Docket Item #9
Development Special Use Permit #2006-0006
3650 Wheeler Avenue-Lindsay Lexus

Application	General Data	
Project Name: Lindsay Lexus	PC Hearing:	April 7, 2009
	CC Hearing:	April 18, 2009
	If approved, DSUP expiration:	April 18, 2012 (36 months)
	Site Area:	76,669 sf (1.76 acres)
Location: 3650 Wheeler Avenue	Zone:	Industrial
	Proposed Use:	Car storage, Repair/Preparation, Clean up services
	Gross Floor Area:	549,558 sf (35,436 sf retail)
Applicant: Lindsay Cadillac Co., Inc., represented by J. Howard Middleton, attorney	Small Area Plan:	Seminary Hill
	Green Building:	Providing 13 points under the LEED system

Purpose of Application
 Development special use permit, with site plan, for redevelopment of existing vehicle preparation and storage facilities in two phases. The first phase includes construction of a new vehicle preparation center, administration office, and surface parking lot; the second phase of the project includes construction of an automated vehicle storage building.

Figure 1: Site Plan – Phase I

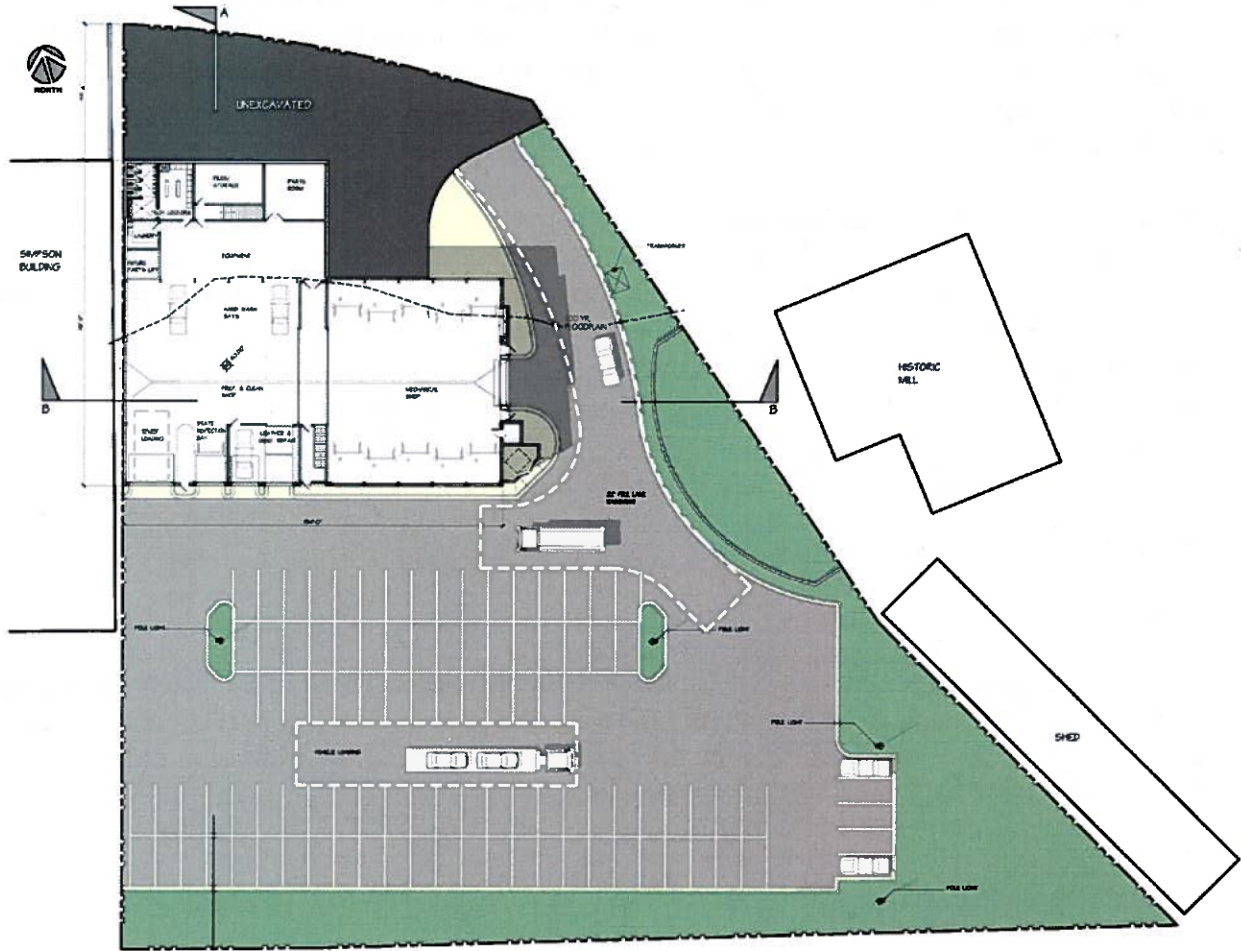
One area of concern for staff was the placement of a large transformer with a seven-foot-tall masonry enclosure structure within this open space area and viewshed of the historic mill. Because of the existing 100-year floodplain, the transformer must be provided in this location as it serves the Flippo Construction site and well as the subject site. Staff has recommended that the enclosure be eliminated and that the transformer be screened with a naturalistic mix of plant materials so that it blends in with the landscaped open space.

Staff is also recommending that the amount of open space at the eastern façade of the new administrative building be increased by reconfiguring the ADA parking spaces and ADA ramp in this location. This reconfiguration will also result in a shorter and more comfortable ADA ramp to the building entrance.

- d. Reconfigure the ADA parking spaces, correct the parking space dimensions and provide additional open space area between the parking spaces and the administrative building as generally depicted in Attachment #1. The landscape plan shall be revised in coordination with this requirement.

- e. Eliminate the enclosure around the transformer, minimize the size of the concrete pad, and screen the transformer from view along Wheeler Avenue with a variety of plants. The service opening for the transformer shall be oriented to provide the least objectionable view.

- f. The transformer location is limited by pre-existing conditions. The final placement shall minimize impact on the historic mill. The landscape plan shall prioritize screening of the transformer with a natural planting scheme.

Figure 7: Staff recommended refinements to north and east facades of the vehicle storage building

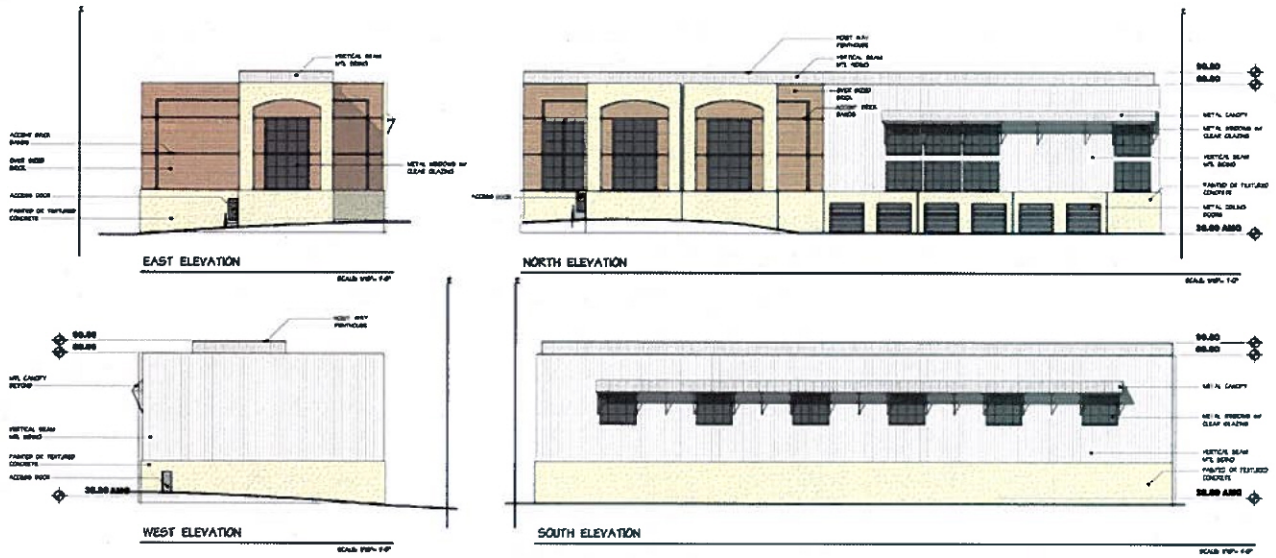
Staff and the applicant have worked substantially on the design of the storage building. The design of this building has evolved from incorporating elements recalling brick materials found in the old grist mill structure to simplifying the language by extending the metal-cladding and concrete expression. Staff has added conditions of approval addressing this design refinement.

Even though the use of vehicular lifts in the current proposal has substantially reduced the size of this structure, building materials were streamlined to deemphasize the horizontal lines. Metal siding with vertical seams and windows of various proportions on the north façade add articulation to the building exterior.

15. The applicant shall provide the following building refinements to the satisfaction of the Director of P&Z:
 - a. Refine the design of the vehicle storage garage as depicted in Attachment #2.
 - b. Color architectural elevations showing various glazing types shall be submitted during final site plan review. Glazing samples shall be provided for approval. (P&Z)
16. The final materials, details, and color selection for both buildings shall be reviewed and approved as part of the final site plan review. (P&Z)
17. The applicant has agreed to incorporate sustainable design elements and innovative technologies into the project and achieve 13 points under the LEED Green Building Rating System for New Construction. As part of the Final Site Plan review process, the applicant shall explore the possibility of incorporating a cistern into the project. (P&Z)(RP&CA)(T&ES)
